**REVISION 003 TO A
INVITATION TO TENDER**

Title - Sujet : Lake Louise Waste Water Treatment Plant Rehabilitation – Banff National Park	
Solicitation No. - N° de l'invitation : 5P420-20-0448/A	Date : April 12, 2021
Amendment No. - N° de modification : 003	
Client Reference No. - N° de référence du client : 1480	
GETS Reference No. N° de référence de SEAG : PW-21-00949500

Amendment 003

This amendment is being raised to extend the solicitation closing date, distribute questions and answers, to make changes to the tender package and make changes to Appendix 1 – Combined Price Form.

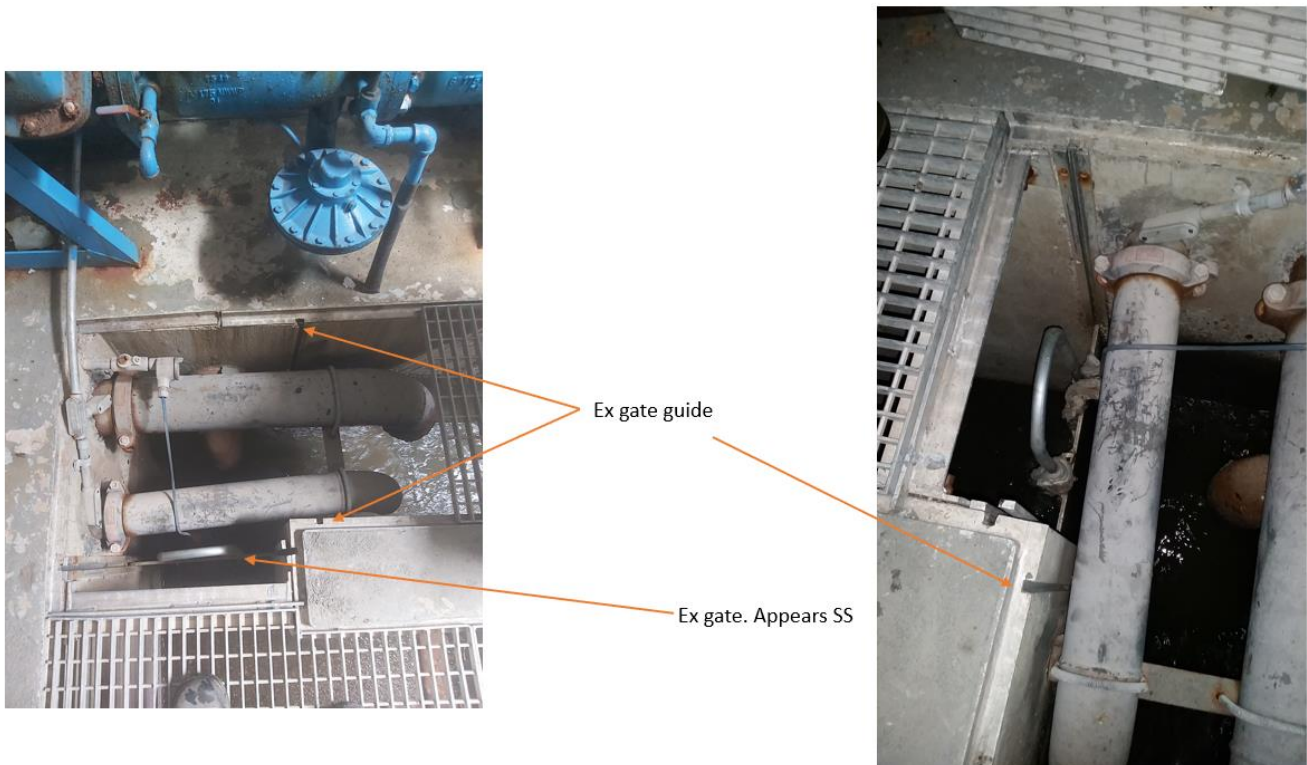
Q44. Reference drawing 2.M1-01, this suggests that LPUH-2 to 3, and the piping (bold) are new, but are not within the schedules, please clarify.

A44. LPUH-2,3,4 are to remain with the existing branches and individual piping in place. Refer to Note 2 on the drawing 2.M1-01 regarding the re-supporting of the unit heaters.

- Refer to all notes on the drawings.
- 20-LPG-BS to the new Mechanical Room is the only new propane line in the building.
- Additional Clarification, backflow preventer for fridge water connection:
 - Drawing 2.M5-03, 10mm DCW connection to FRG-1. Model Watts - Series LF009 Reduced Pressure Zone Assembly (connect BFP discharge to the nearest drain upstream the DSK-1 p-trap)

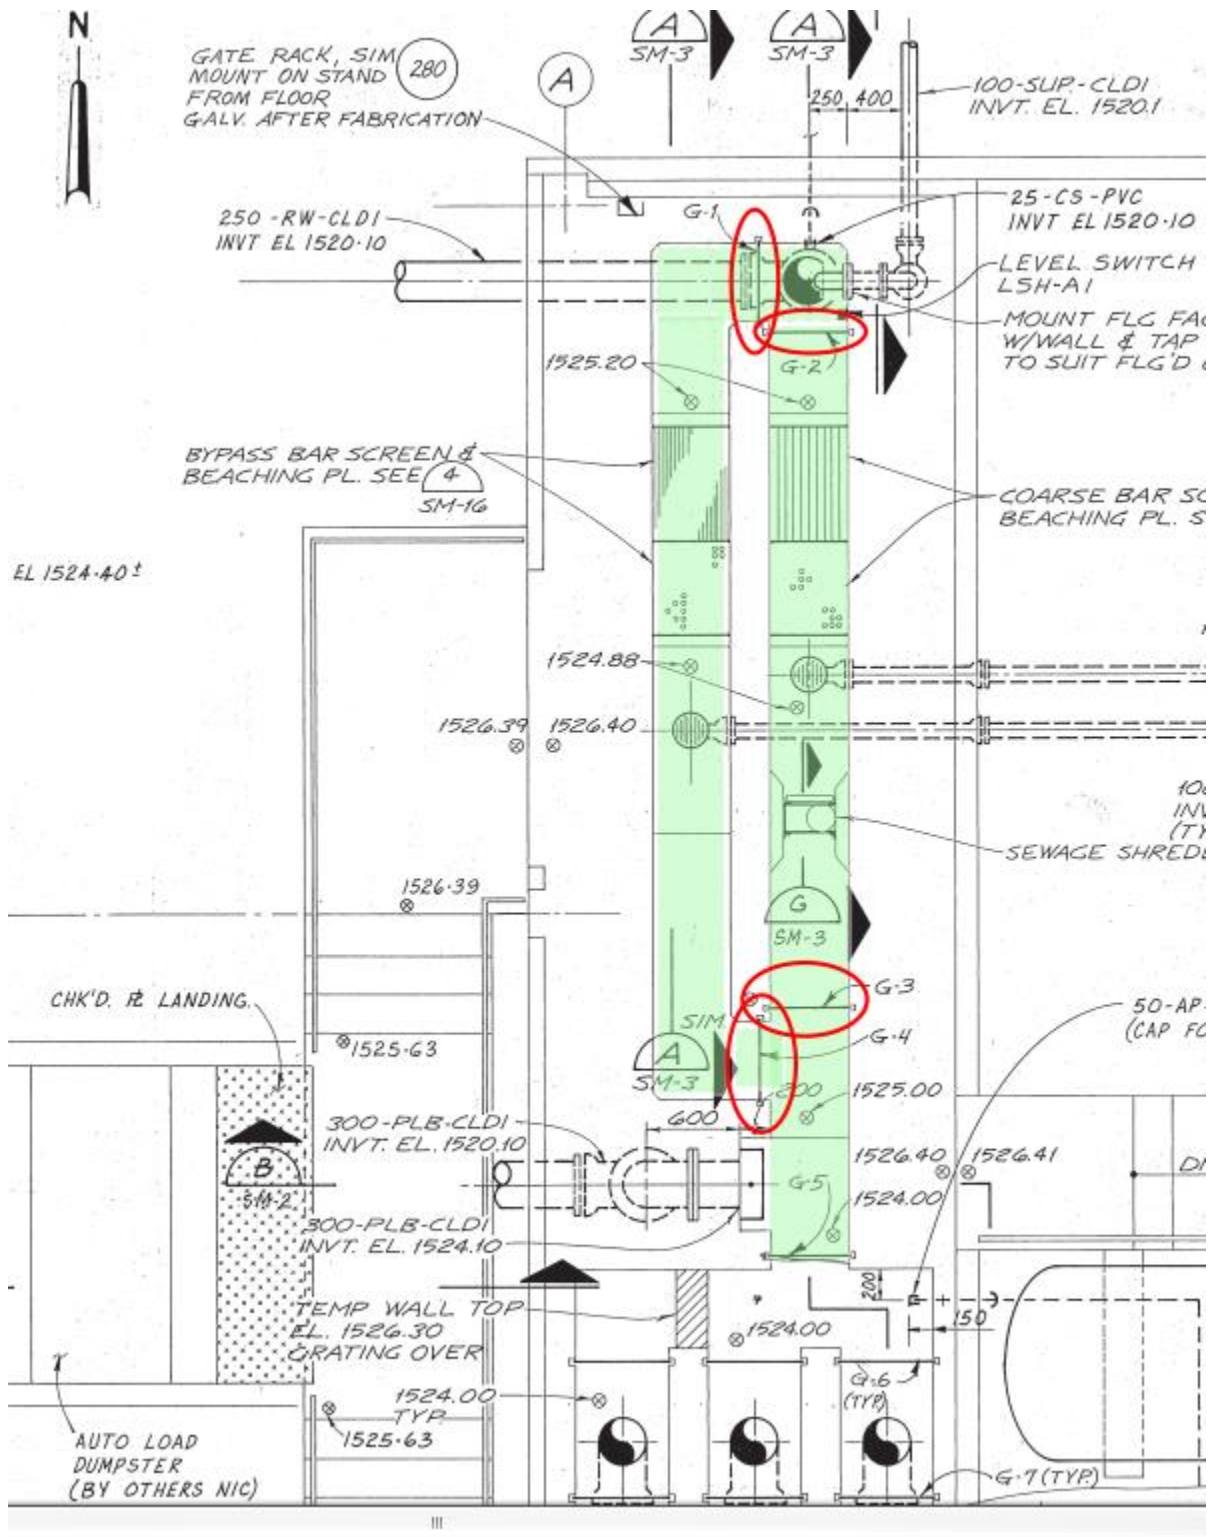
Q45. Reference drawing 2.P2-01 and the Screen:

- a) We cannot see if there are any gates to shut down the main channel and use what looks like a bypass channel, please clarify if we are to bypass the screen during the works, and if so how.

A45a). Please see drawing and photos below for locations of the channels and four (4) isolation gates.
